### PIP5319F Rattle From the Turbocharger on Cold Start

#### Models

Brand:	Model:	Model Years:	VIN:		Engine:	Transmissions:
			from	to		
Cadillac	CTS-V Sport	2014 - 2016	All	All	LF3 Turbo	All
Cadillac	XTS	2014 - 2016	All	All	LF3 Turbo	All

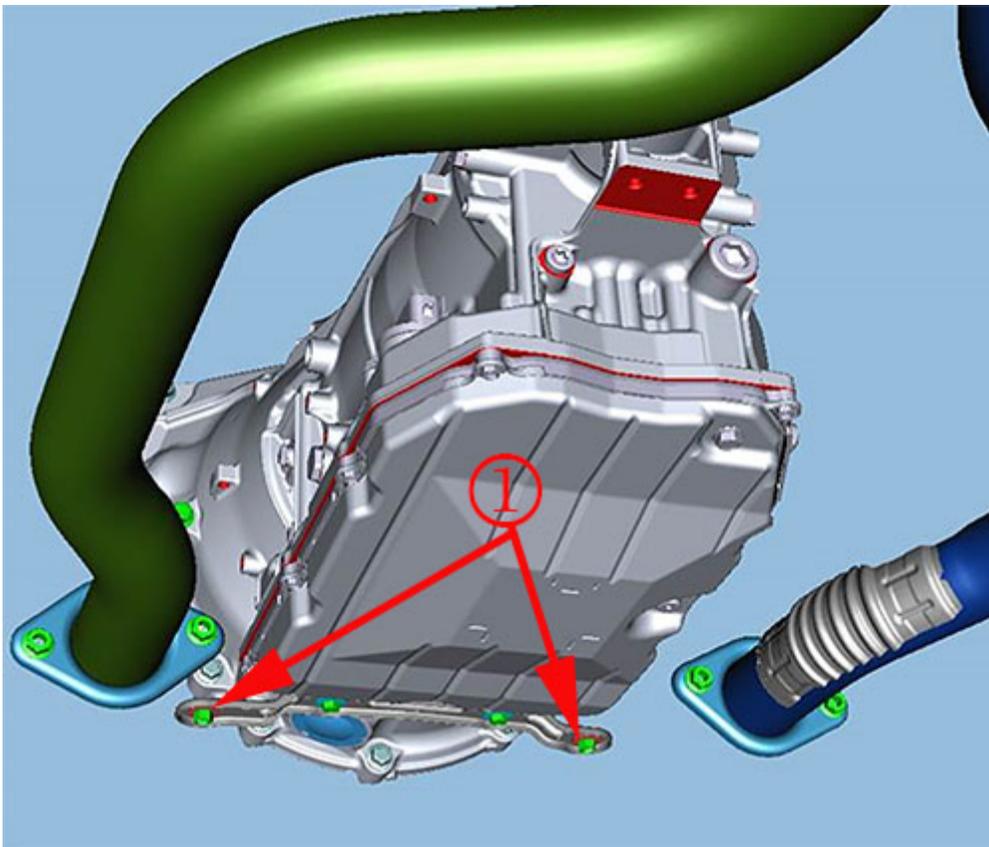
**Inspect the exhaust converter bracket nuts that secure the converters to the bracket prior to replacing any parts.**

**Inspect the M8 nuts noted in the picture that secure the catalytic converters to the exhaust bracket.**

**Over time during normal operating conditions these nuts can lose torque and cause a rattle that sounds like it is coming from the turbocharger.**

**If technician finds the M8 nuts are loose it will be necessary to replace them with new torque prevailing nuts, P/N 11546441 LF3 (2 nuts).**
